### **FIELD SERVICE BULLETIN**

FSB Number: LVCCFSB2006-136  
Authors: Darwin Garcia  
Date: April 7, 2006  
Total No. of Pages: 2  
Subject: **V3 P-Flex Corrosion**  
Model Affected: **V3**  
Level of Repair: 2

Corrective action Date Code

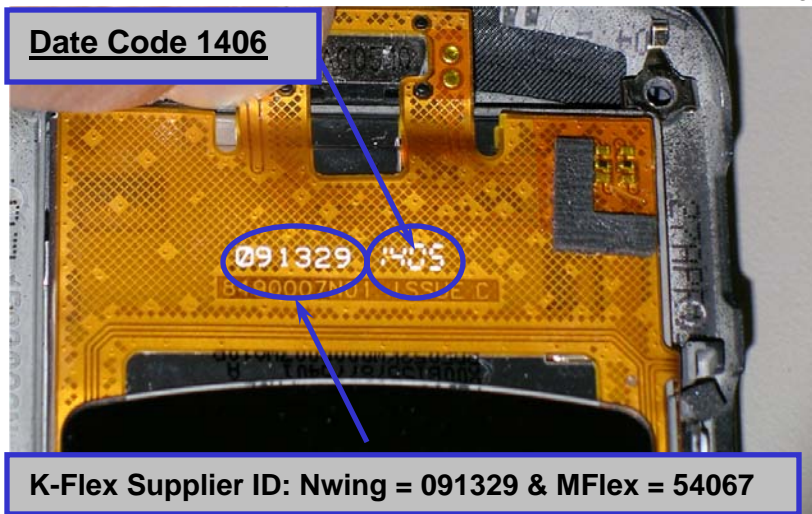
Service has been made aware of a V3 P-Flex corrosion issue causing “Main Keypad - No function/ hangs & Side Keys - No function” complaints.

The root cause was determined to be contamination between gold fingers of P-Flex introduced by the masking process during manufacturing at the supplier.

The supplier changed the SOP to remove the tape mask which traps chemical residue at gold fingers. Implemented on March 30<sup>th</sup>.

When servicing any V3 customer phones with described issue, the P-Flex must be replaced. Personality Flex Assy # 8490007N01
